# Notice of Allowability

10/570,592

BABBINI, LIONELLO MORANDO

### **EXAMINER'S AMENDMENT**

FIG. 7

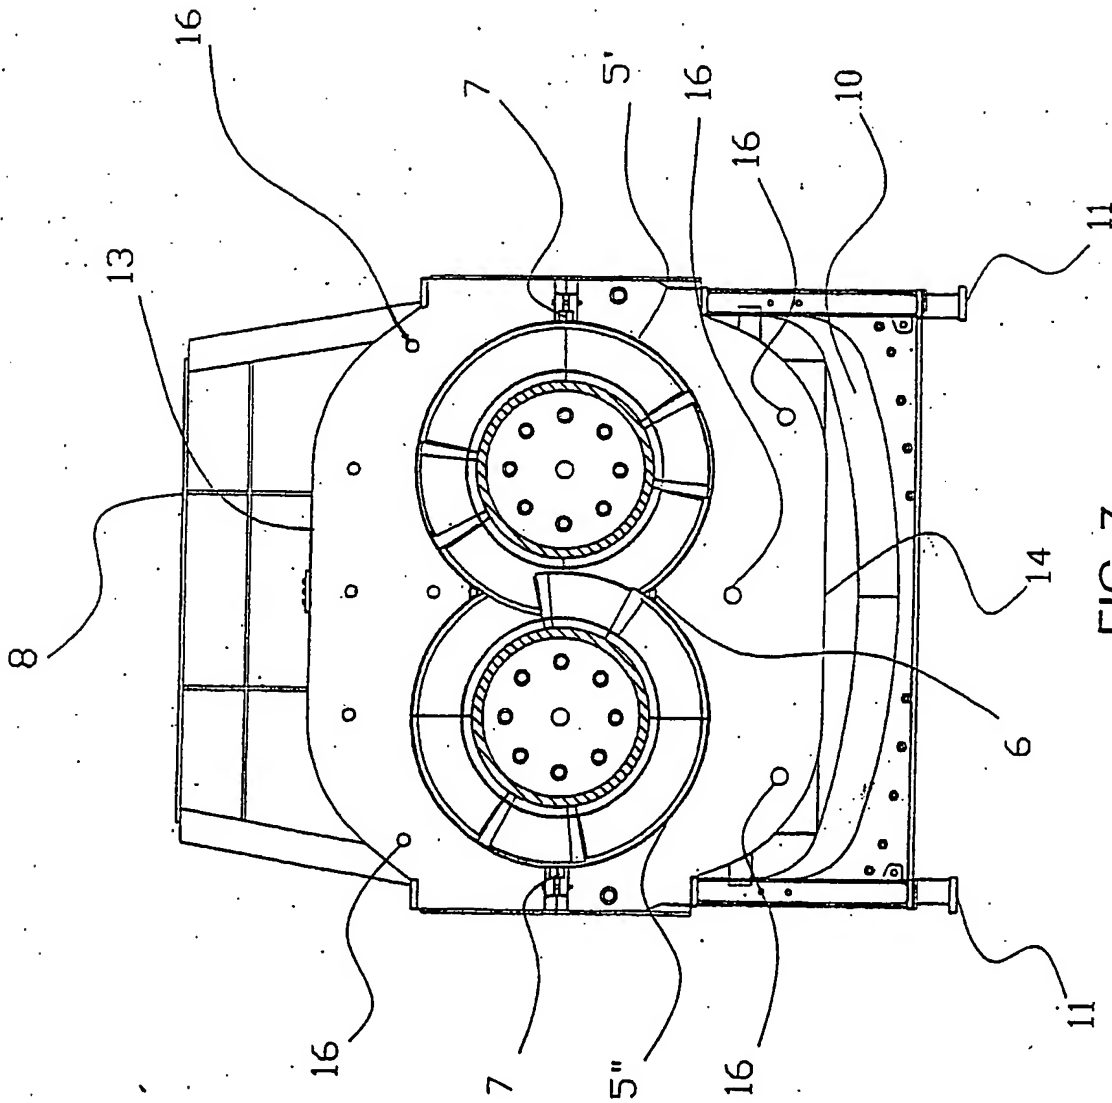
The proposed drawing correction filed on February 08, 2007 has been acknowledged and approved. The drawing correction sufficiently overcomes the drawing objections noted in the previous Office action.

*Approved*  
*VTN - 3/26/2007*
